# SERVICETEKNOTES

## TABLE OF CONTENTS

SC504 HALO SUPPRESSION ADDED (cont.)

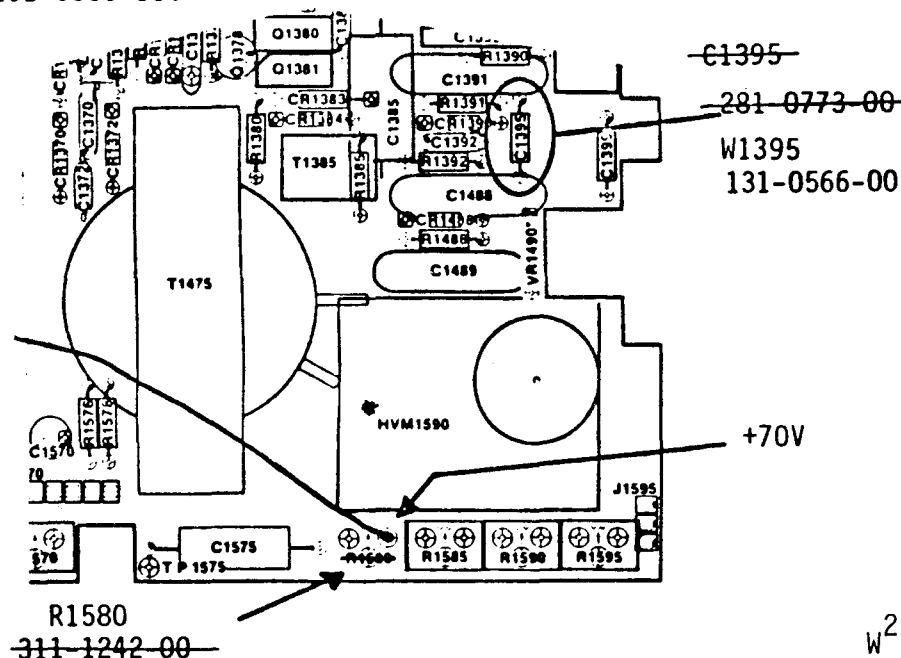
1. V1000 CRT changes to P/N 154-0859-00

2. C1395 replaced with W1395, wirestrap, P/N 131-0566-00.

3. R1580 removed.

4. Add a 6 inch length of wire from pin 13 of the CRT socket to the +70 volt terminal from which R1580 was removed.

FIGURE 1

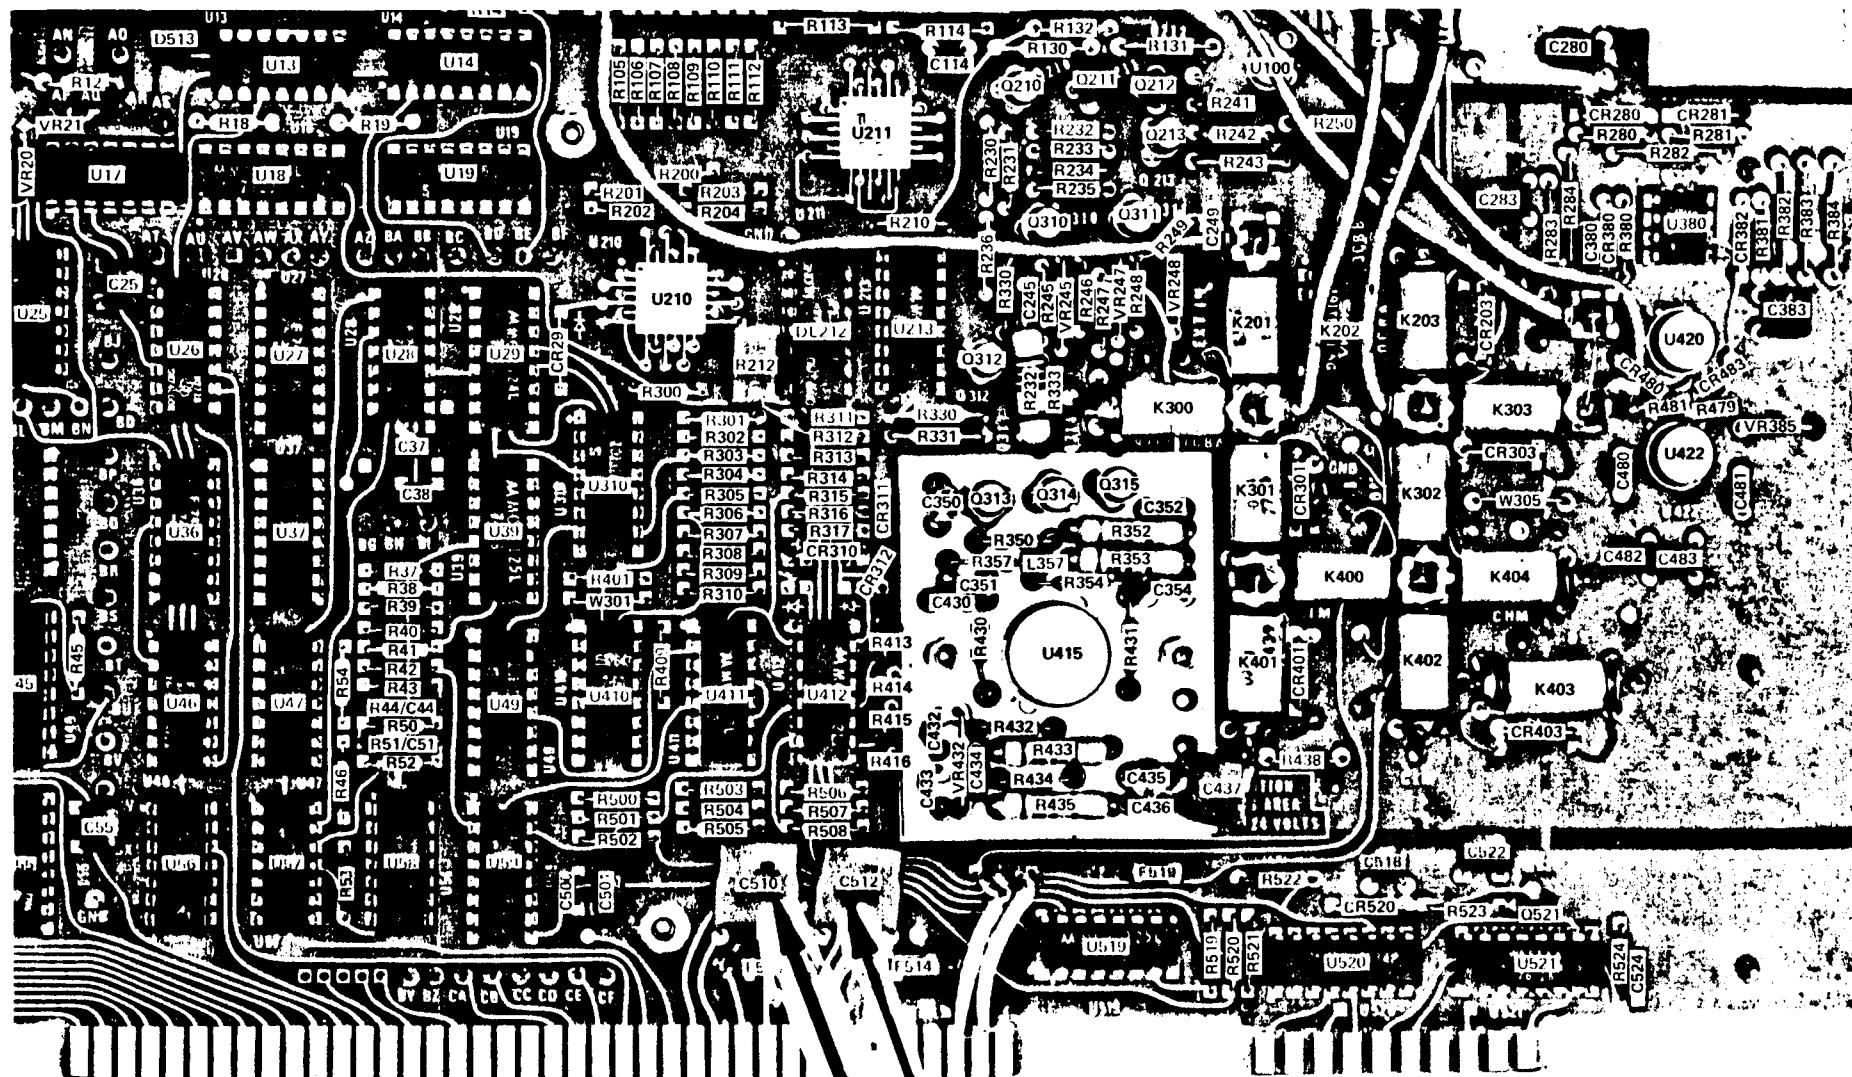
C510, C511, C512, and C513 with 4 each, Capacitor 0.22uf, 10%, 100V (285-1241-00). Replace 2 each, Capacitor 1uf, +80-20%, 25V (283-0177-03) located at C443 and C453 with 2 each, Capacitor 0.1uf, 20%, 50V (283-0111-00). The D70 Pin Electronics Card changes from 670-5347-03 to 670-5347-04. See Figures 1, 3, 4, and 6.

C510 & C513

Remove: 4.7uf(283-0194-00)

Add: 0.22uf(285-1241-00)

C511 & C512

Remove: 4.7uf(283-0194-00)

Add: 0.22uf(285-1241-00)

C443 & C453  
Remove: 1.0uf(283-0177-03)  
Add: 0.1uf(283-0111-00)

FIGURE 2

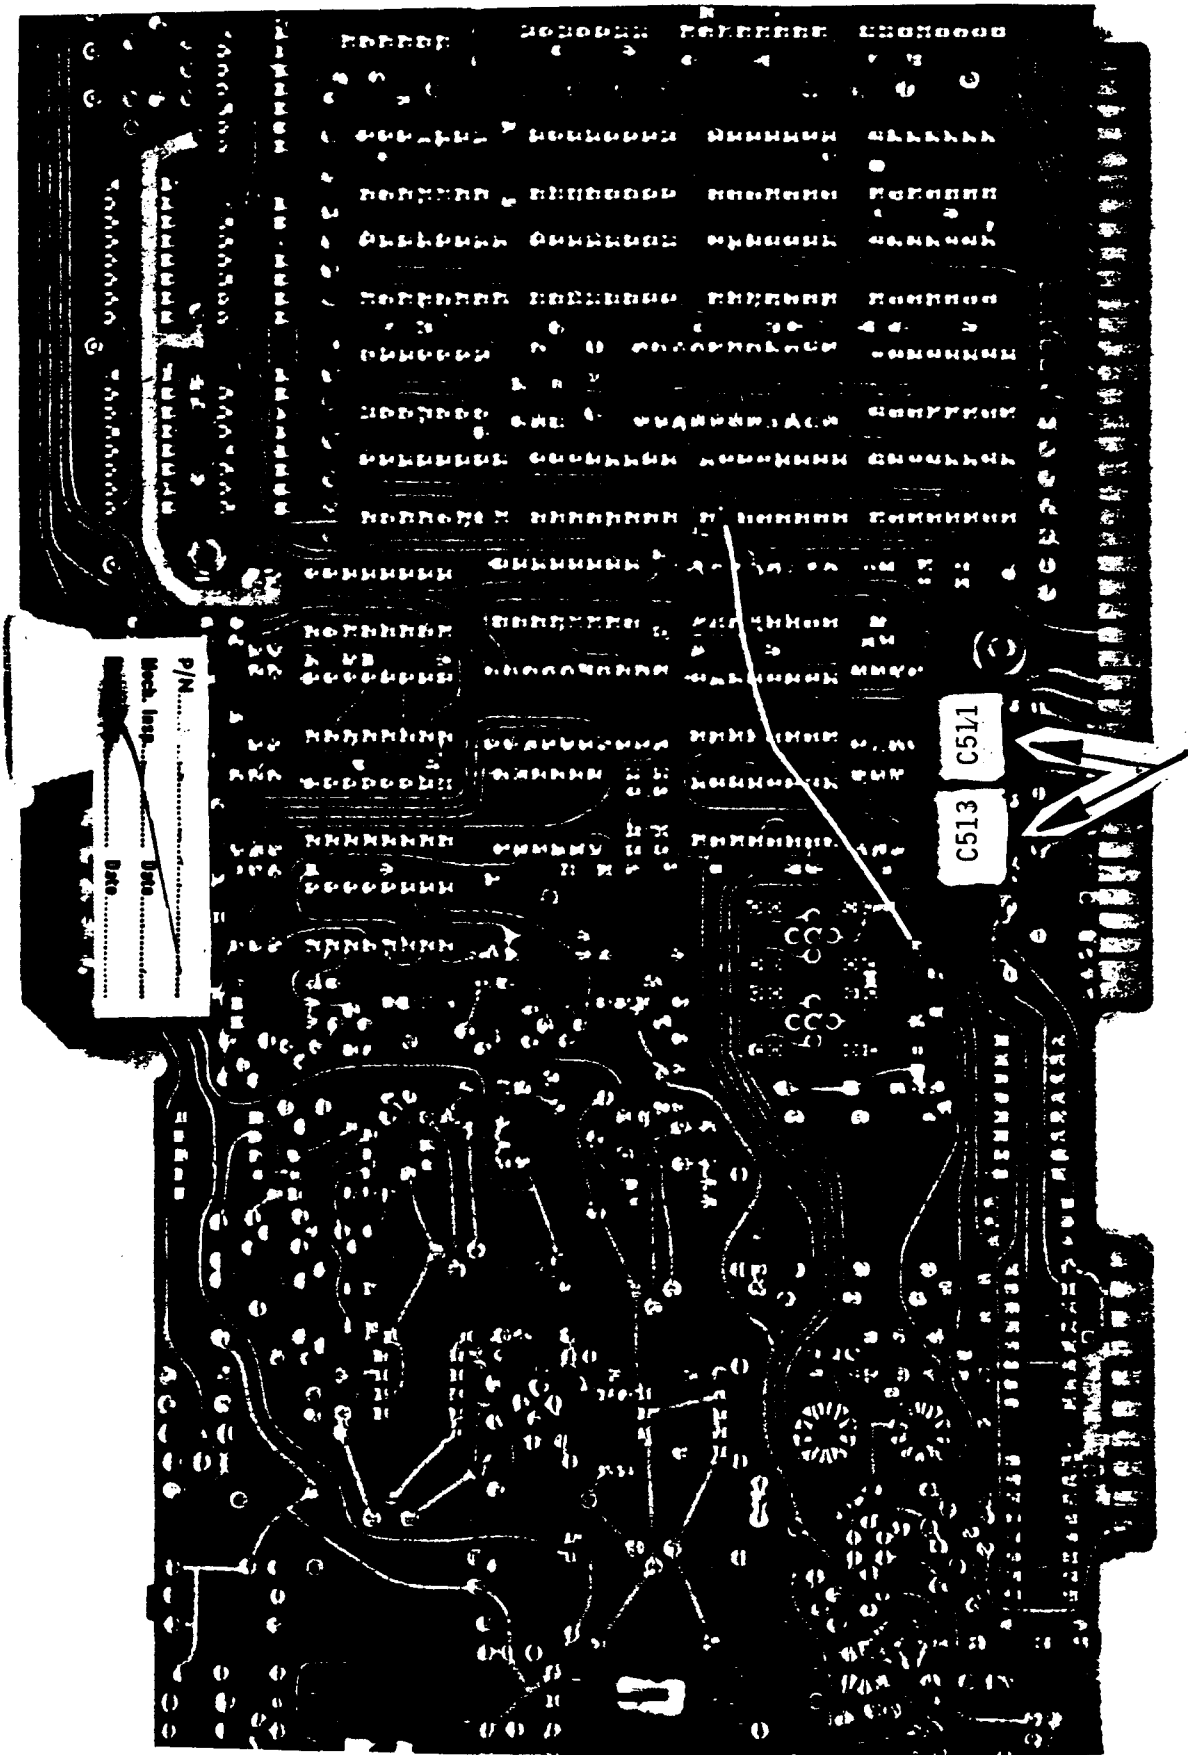
Replace 4 each, Capacitor 4.7uf, 20%, 50V (283-0194-00) located at C510, C511, C512, and C513 with 4 each, Capacitor 0.22uf, 10%, 100V (285-1241-00). The D80 Pin Electronics Card changes from 670-5412-02 to 670-5412-04. See Figures 2, 3, and 5.

- C512 Remove: 4.7uf(283-0295-00)  
Add: .22uf(285-1241-00)
- C510 Remove from Front: 4.7uf(283-0194-00)  
Add to Backside: .22uf(285-1241-00)
- C511 Remove from Backside: 4.7uf(283-0294-00)  
Add to Front: .22uf(285-1241-00)
- C513 Backside Remove: 4.7uf(283-0294-00)  
Add: .22uf(285-1241-00)

FIGURE 3

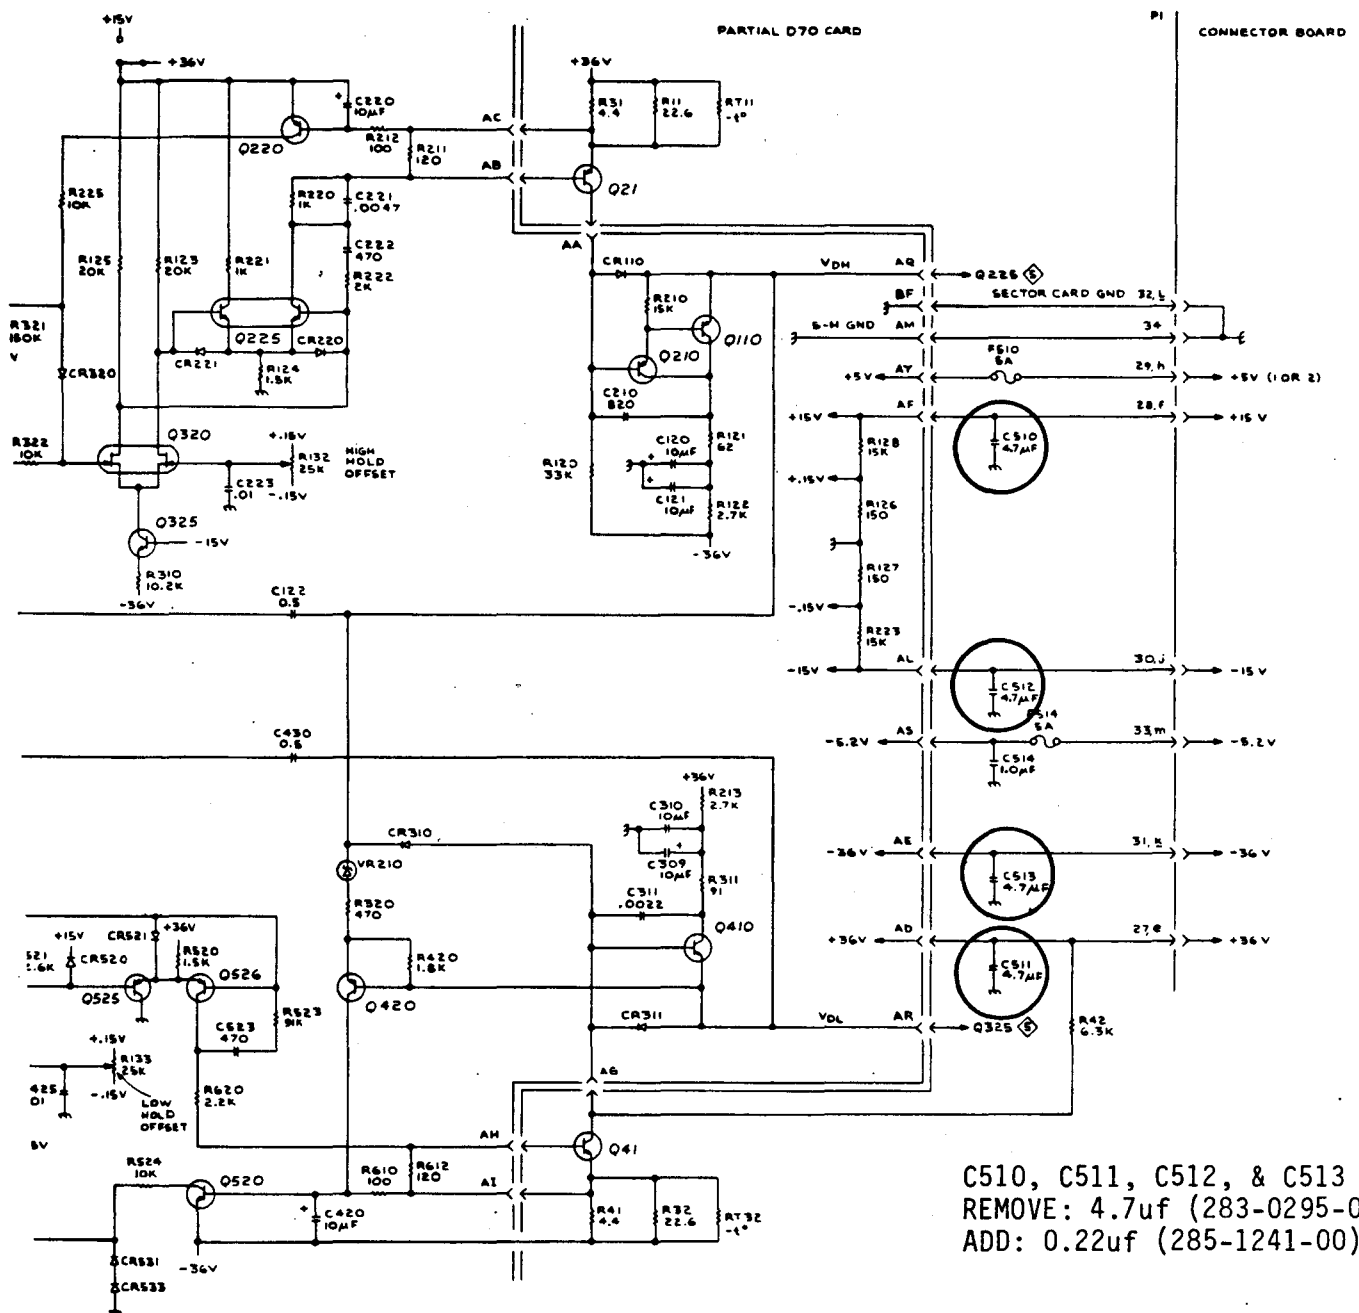
CAPACITOR LOCATIONS FOR D70 & D80 PIN CARDS

D70 & D80 BACKSIDE PIN ELECTRONICS CARDS

FIGURE 4

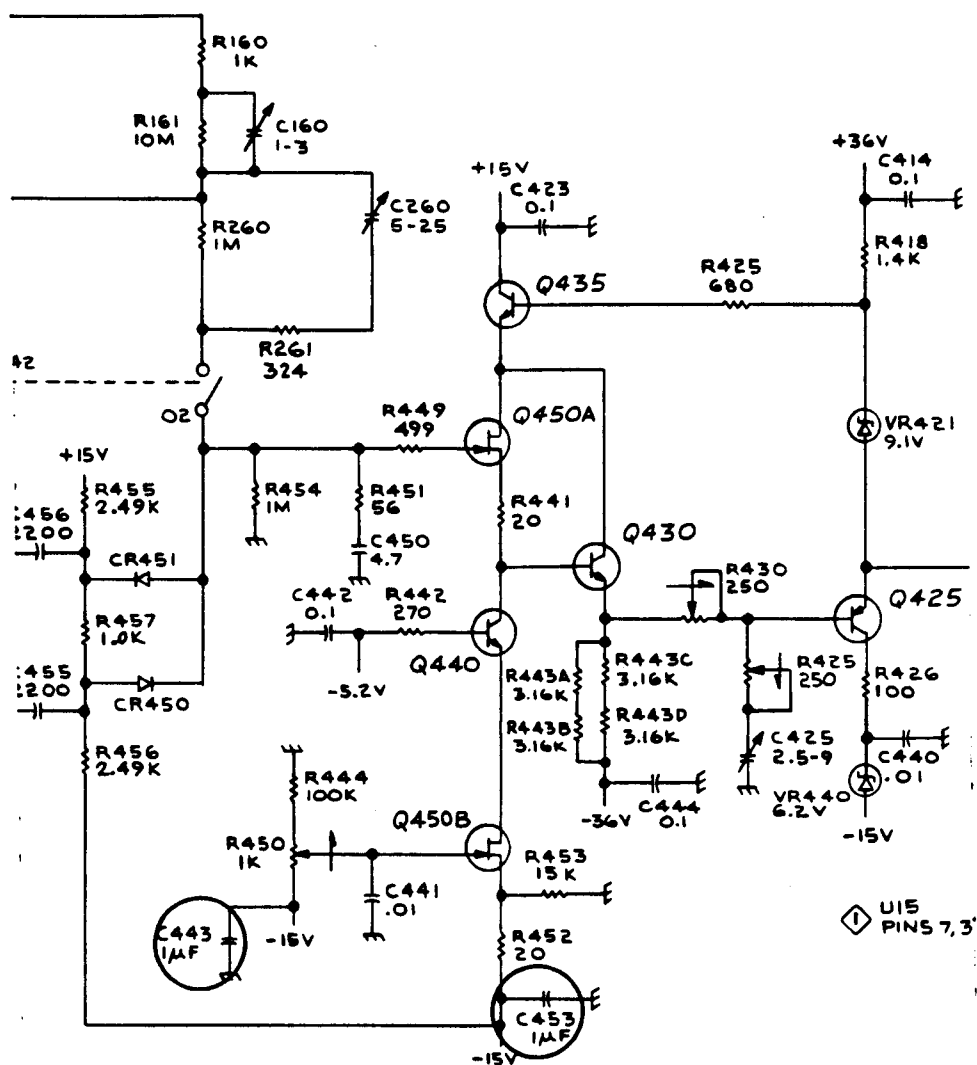
C443 & C453  
 REMOVE: 1uF (283-0177-03)  
 ADD: 0.1uF (283-0111-00)

### 606B OUTPUT AMPLIFIER MODIFICATION 46302 (cont.)

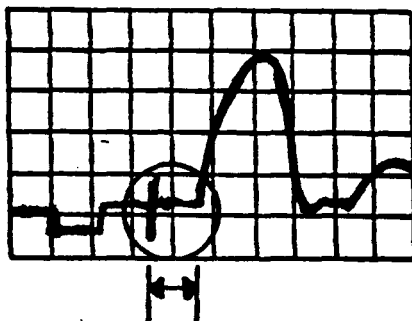
Modification 46302 changes R133, R139, R233, and R239 from 91 ohms to 62 ohms, 5%, 1/4 watt (p.n. 315-0620-00), SELECTED. The "selected" in the description means that 62 ohms is only a nominal value and that other values may be substituted.

The optimal value for the four resistors is found by trial and error according to the following guidelines:

- If a 606B fails the bandwidth specification, the values of R133, R139, R233, and R239 need to be reduced.
- If the product fails settling time specifications (excessive ring on

the front corner), the resistor values must be increased.

- If a change in value is necessary, all four resistors must be increased or decreased by the same amount.

### 1800 ACTUATOR ARM IMPROVEMENT KIT 050-1558-00 (MOD M44006)

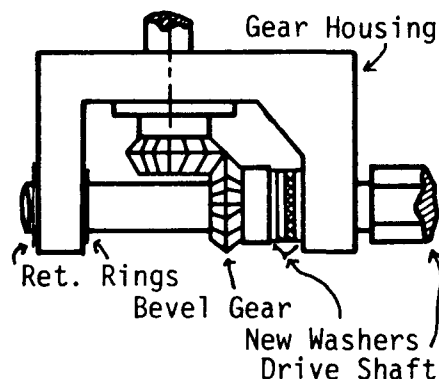
The 050 kit replaces the drive shaft with a new drive shaft, P/N 384-1298-01. The new drive shaft has had two snap ring slots made deeper and has had the third retainer ring slot deleted. A combination of steel and brass washers are used to obtain proper gear alignment.

Typically, it takes three steel washers and one (or two) brass washers. The thrust washers remove the stress of cranking the table from the snap rings. The stress is now on the level gear, washers, and gear housing, thereby keeping the level gear aligned. (See figure on next page).

GROUND IMPROVEMENT

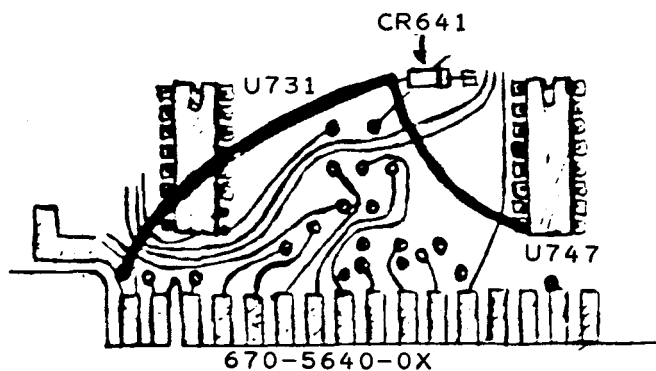
The cause of this phenomenon has been  
traced to noise on the Display Control  
boards, 670-5640-02 and below. The  
final fix will be a layout change to the  
ECB which will add a ground plane and a  
+5 volt plane. On the current boards  
there are only runs for these functions.

The manufacturing line has been hand ad-  
ding number 26 gauge wire in strategic  
points to better ground out the noise.  
This is not considered a modification  
because the ground runs are already  
there. Also the revision level of the  
board does not change.

The wire is added from Buss pin 72 to  
the anode of CR641 and to U747 pin 8 as  
shown in the drawing.
